Title: Advisory Committee Reactor Safeguards
Subcommittee on Power Uprates

Date: Wednesday, April 26, 2006

ADVISORY COMMITTEE ON REACTOR SAFEGUARDS
MEETING OF THE SUBCOMMITTEE ON POWER UPRATES
BEAVER VALLEY POWER STATION EXTENDED POWER UPRATE

Steam Dryer Region

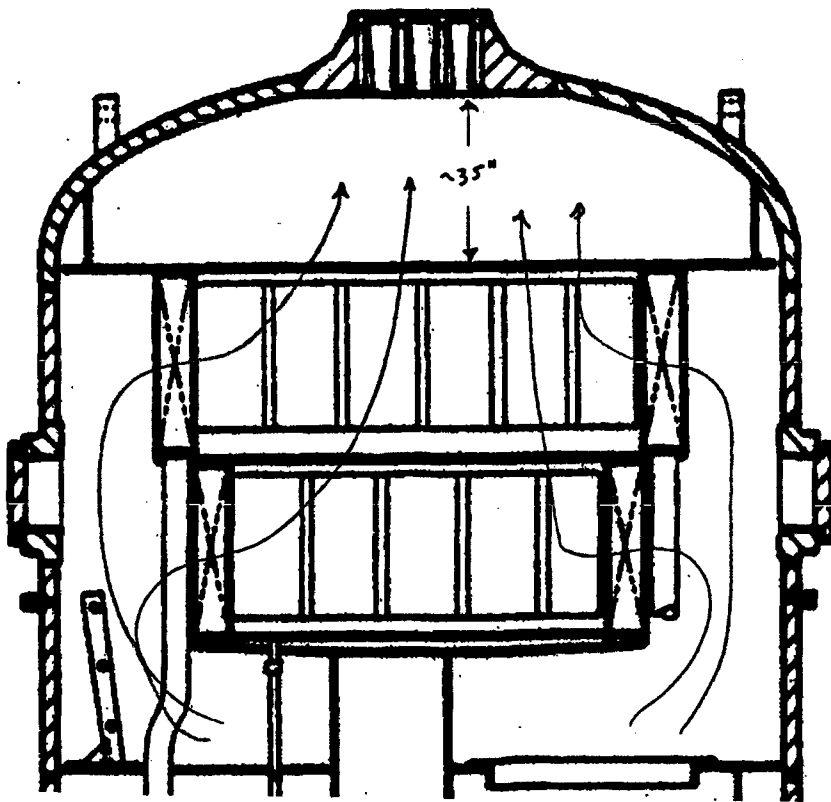
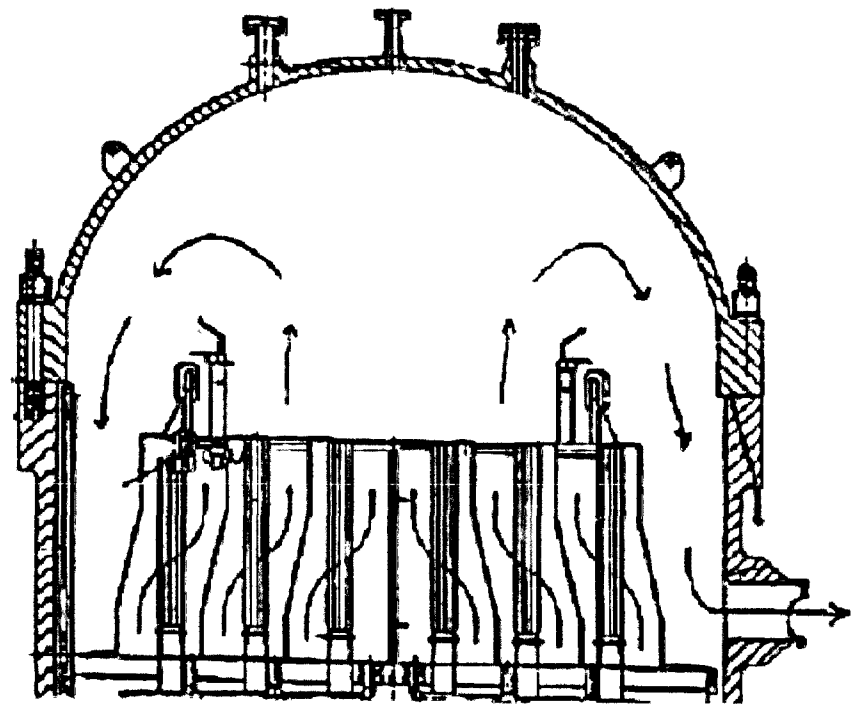
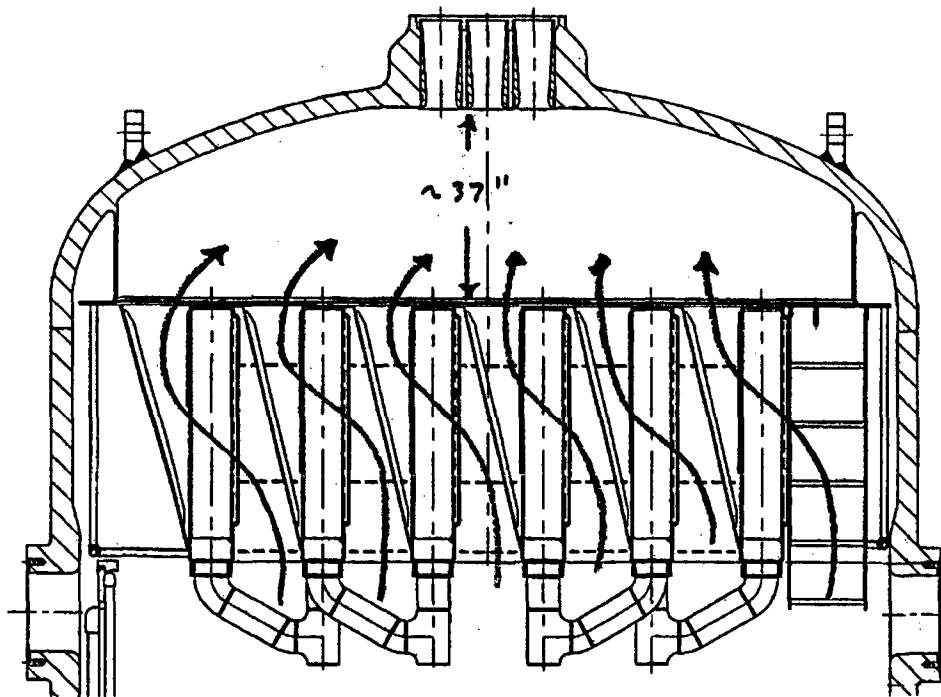
13 Okay. As far as the next slide here, I
14 just wanted to touch on the steam dryer. Again,
15 look at the comparison between the PWR and the BWR.
16 Just a little description on the secondary steam
17 dryers on the steam generators. Now the main
18 difference is between the 51 and the 54 is that the
19 51s have a two tier arrangement for the secondary
20 dryers. I have sketch behind this to show that,
21 whereas the model 54 has a single tier arrangement.

3 MEMBER SIEBER: Well, the one thing you
4 don't have is a 180 degree change of direction.

10 MR. TESTA: Sure. Okay. So for
11 example, you know, well Beaver Valley which is going
12 to operate at 2910. The difference with the model
13 54 one tier secondary dryer in the Unit 2, with two
14 tier you can see the comparison to the other plants
15 that utilize the similar secondary steam dryer
16 arrangement.

17 MR. HALL: Yes, but these are not the
18 only plants to have this particular dryer
19 arrangement, too. There's many more.
